CA2004067159

SEWAGE DISPOSAL SYSTEM

HANS LAASPERE
23 KING JOHN DR
LONDONDERRY N.H. 03053
MAP 9 BLOCK 69 LOT 11
BK 2533 PG. 1566

TYPICAL SECTION OF PROPOSED SYSTEM N.T.S.

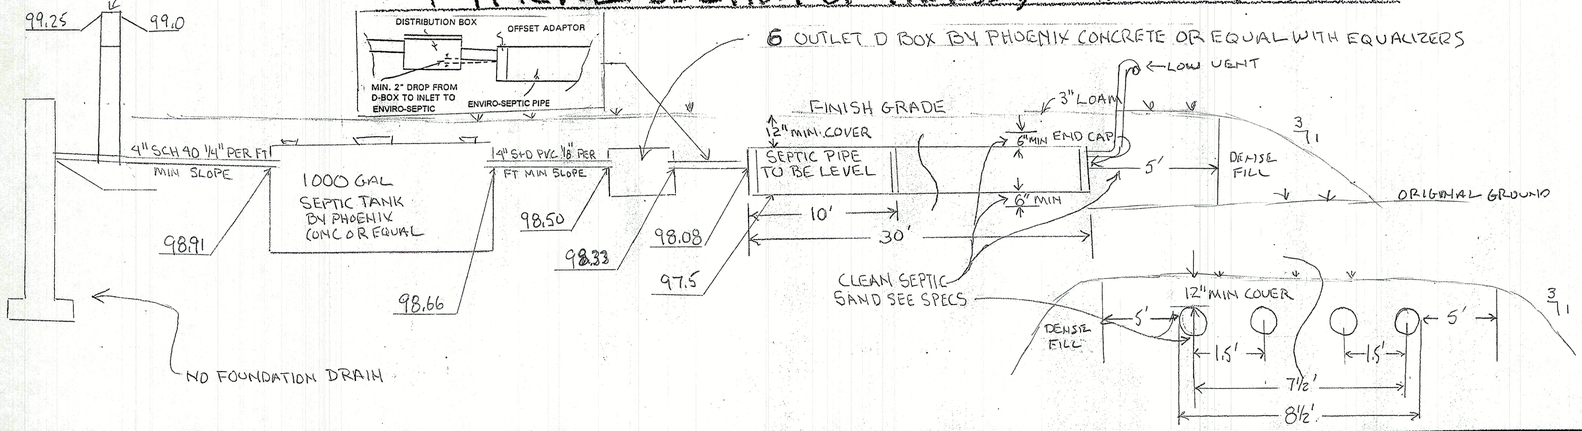
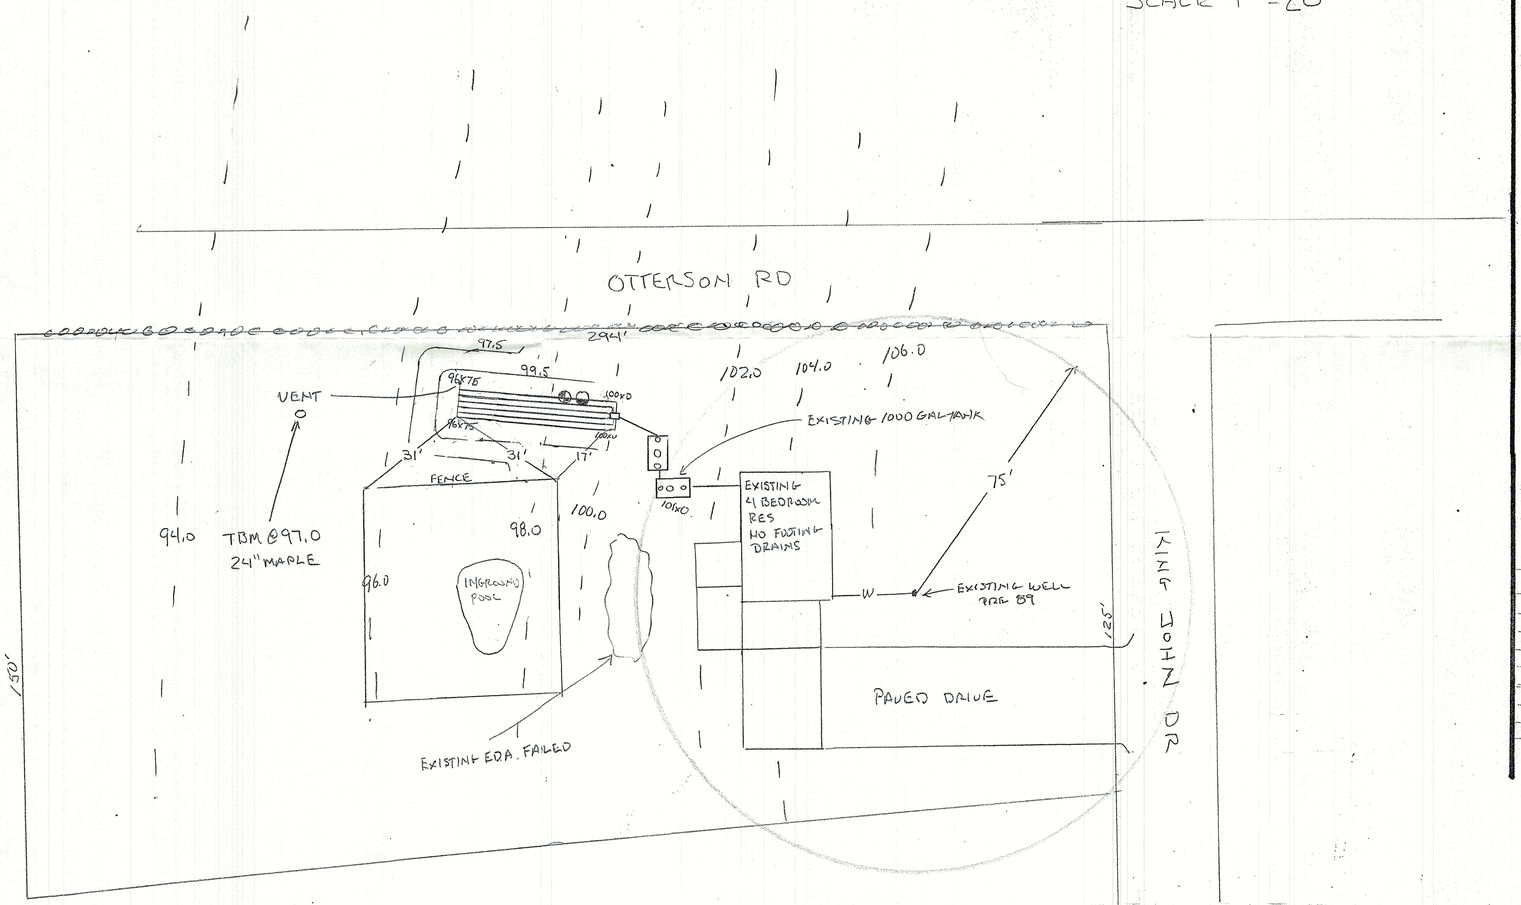
NUMBER OF BEDROOMS 4
DAILY FLOW VOLUME 600
TANK REQUIRED 1500
TANK PROVIDED 2000
SEPTIC PIPE REQ. ~~180~~ FT
PIPE PROVIDED *240 FT
* PER LONDONDERRY REGS.

ADVISE YOUR CONTRACTOR OF REQUIRED CHANGES IN PLANS AS INDICATED ON THIS CONDITIONAL APPROVAL
